NOTICE OF MEETING

The City of Lake Elmo
Planning Commission will conduct a meeting on
Monday March 28, 2022
at 7:00 p.m.

TO: Planning Commission
FROM: Corrin Bemis, Planning Consultant
AGENDA ITEM: **Setback Variance Request at 9404 Lake Jane Trail N**
REVIEWED BY: Molly Just, Planning Director

TO: Planning Commission
FROM: Molly Just, Planning Director
ITEM: H.C. Golf Land, LLC Conditional Use Permit for a Swimming Pool & Fitness Center

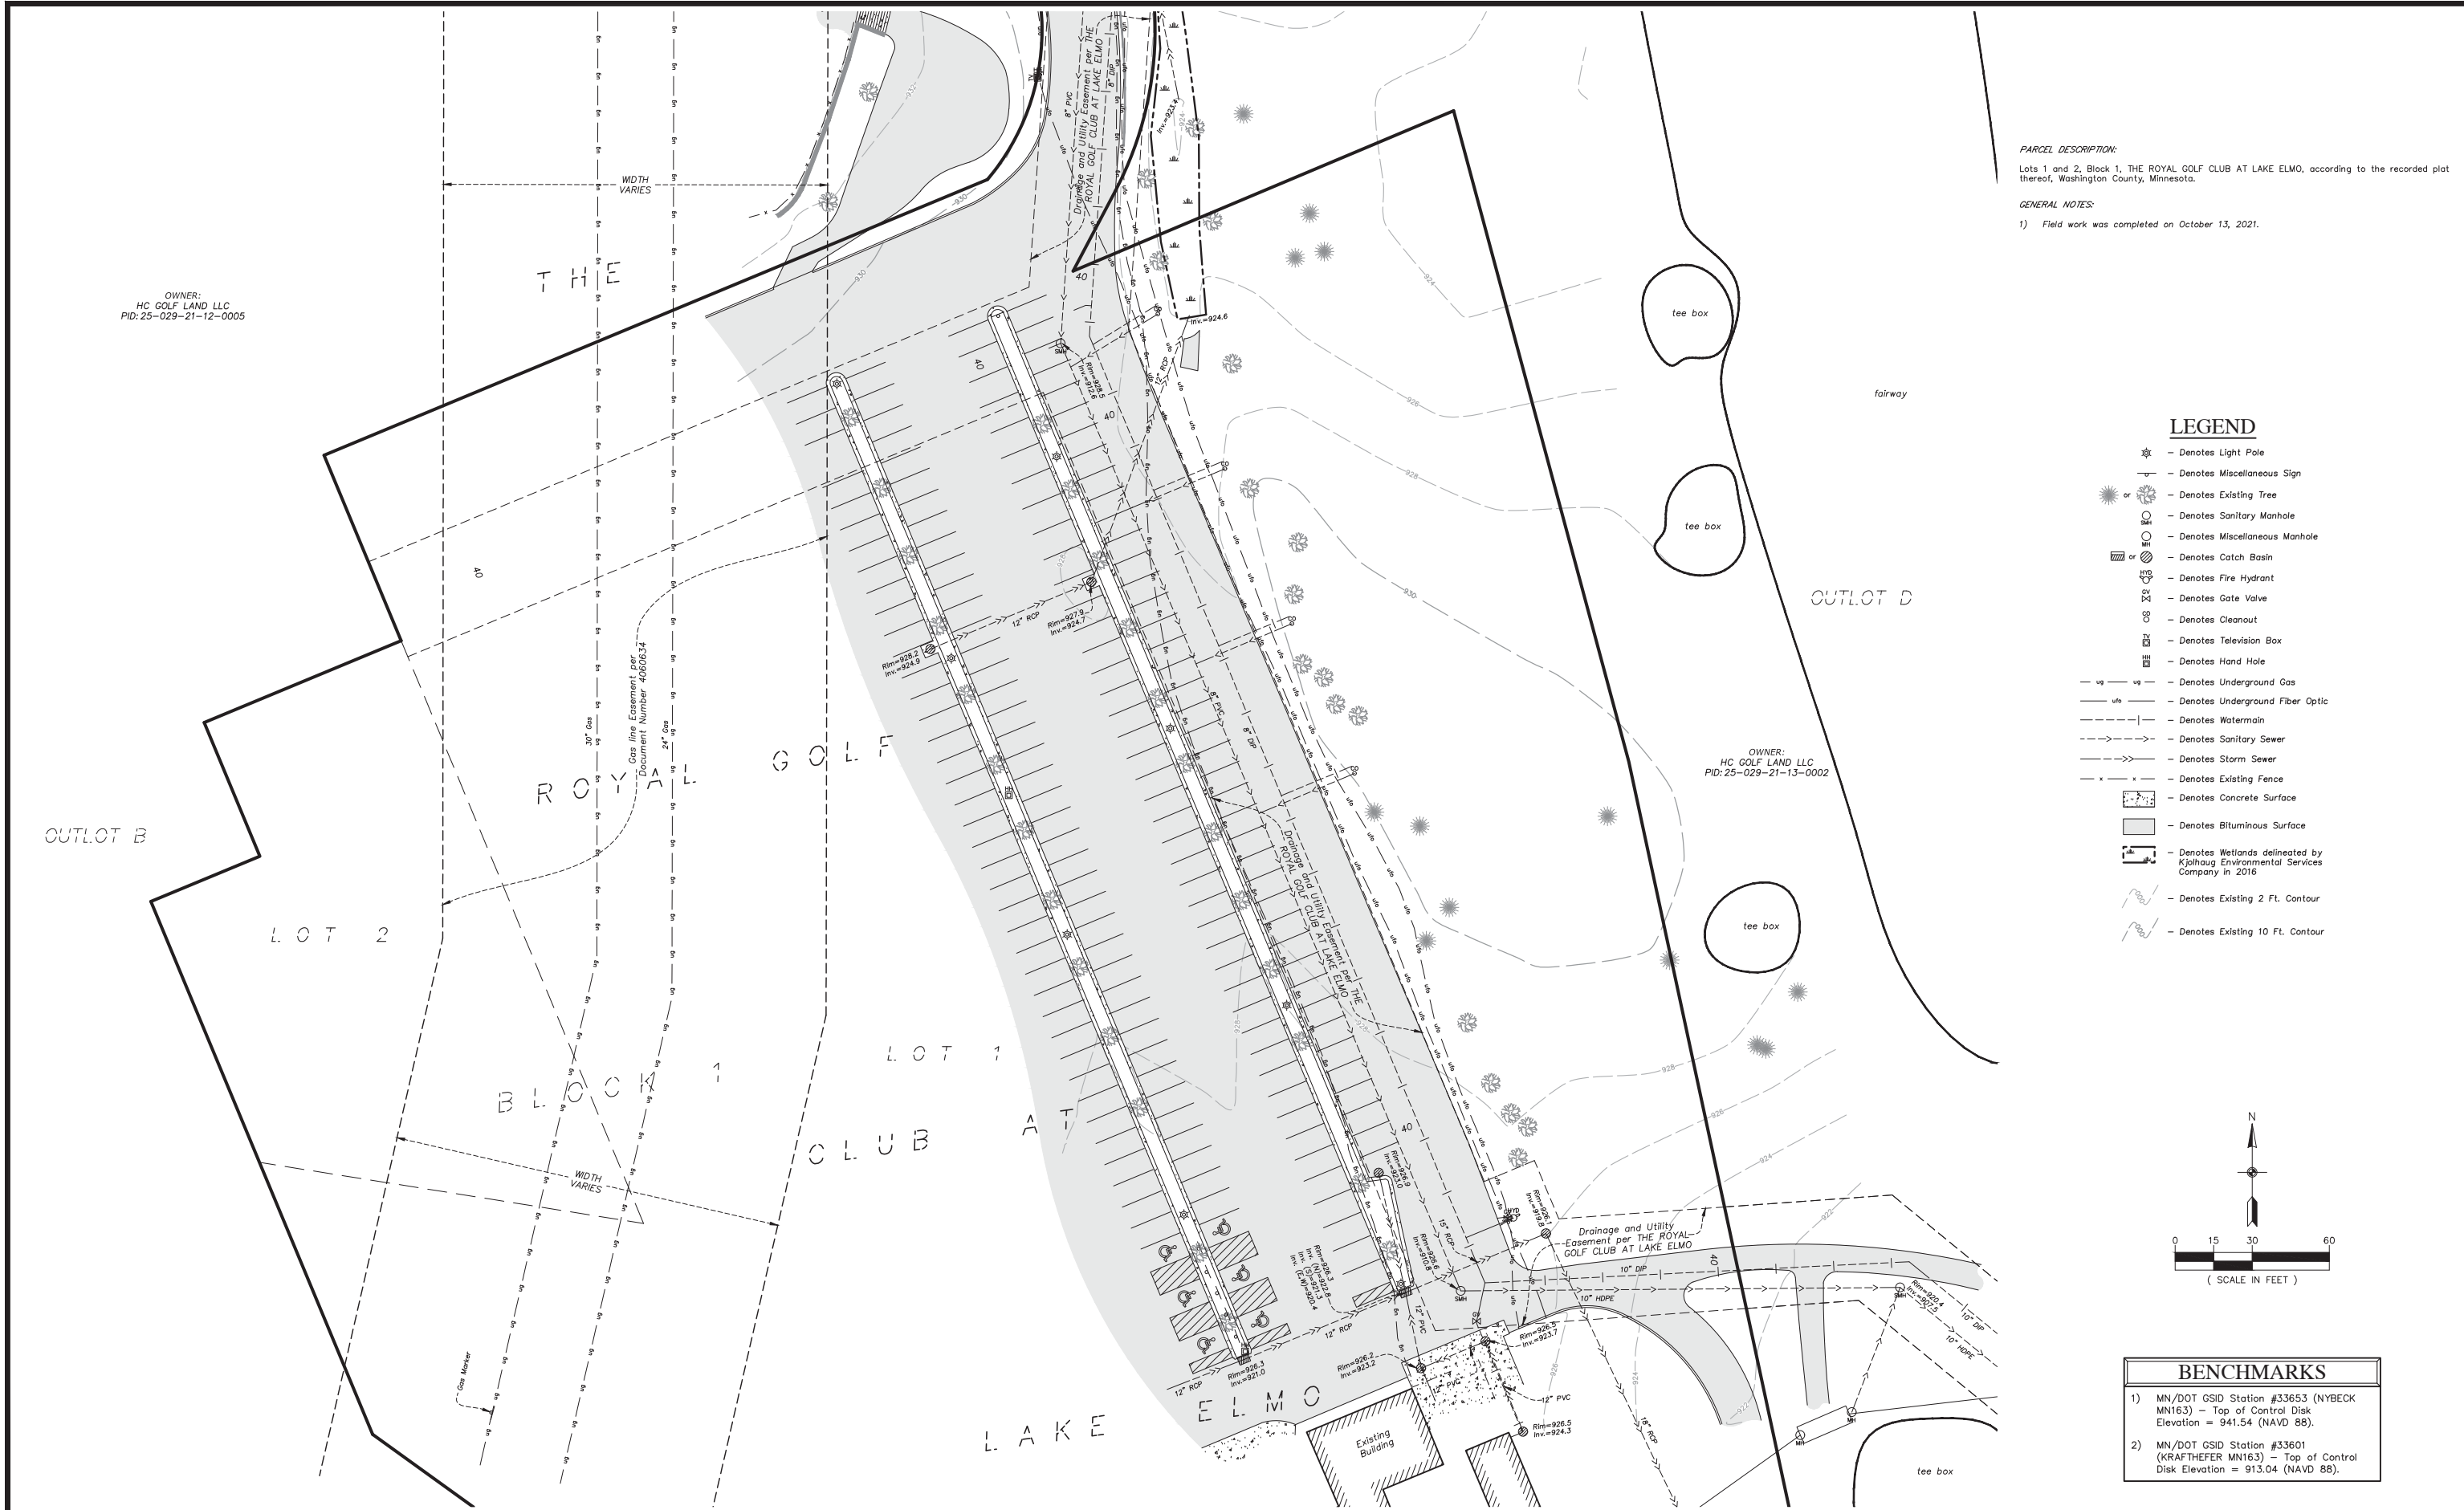
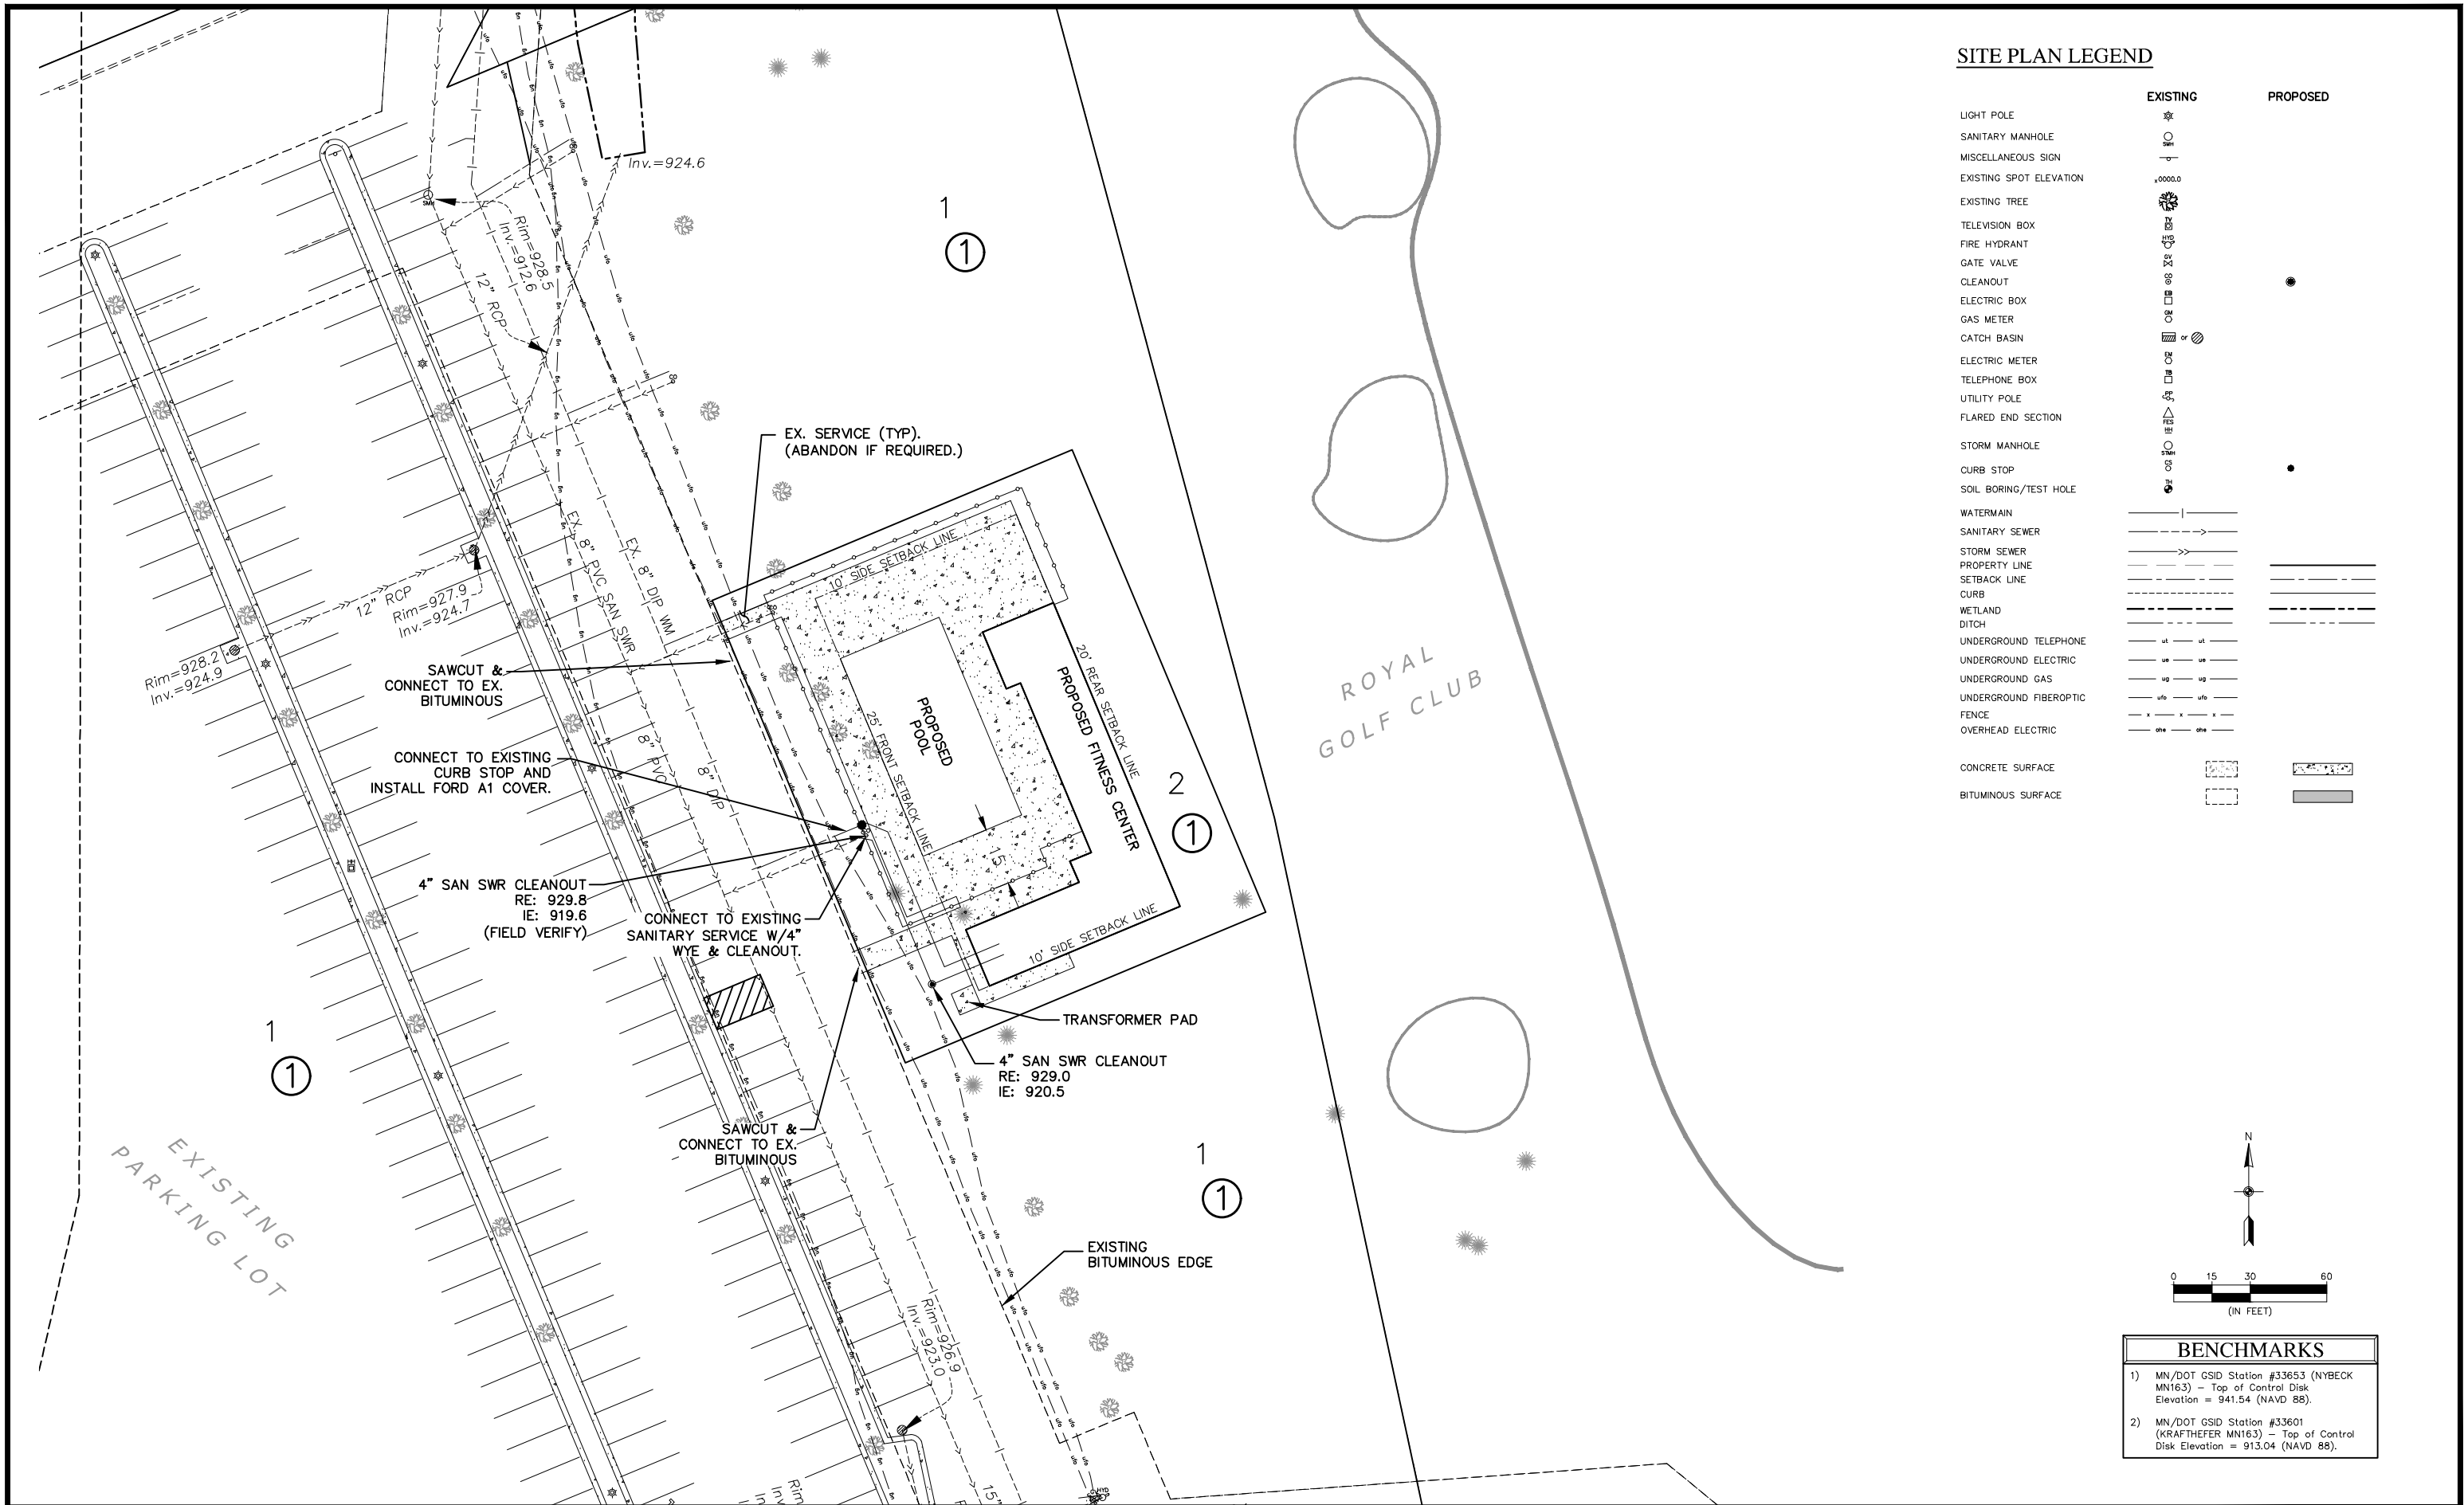
Engineering Review. The City Engineer reviewed this request and prepared the following response.

1. For city record purposes, the application drawings should be updated to provide an additional project location plan that provides the proposed facility location with respect to existing property lines, parcel data and easements. All property and easement line types should be clearly labeled.

6. Stormwater Management. The applicant must identify whether stormwater management will be required for the improvements. VBWD requirements trigger stormwater management for 6,000 SF of impervious surface area. If additional stormwater management is needed, a site grading plan will need to be reviewed and approved by engineering prior to construction.

3. Prior to issuance of City permits for the proposed swimming pool or fitness center the applicant must identify whether stormwater management will be required for the improvements. VBWD requirements trigger stormwater management for 6,000 SF of impervious surface area. If additional stormwater management is needed, a site grading plan shall be reviewed and approved by engineering prior to construction.
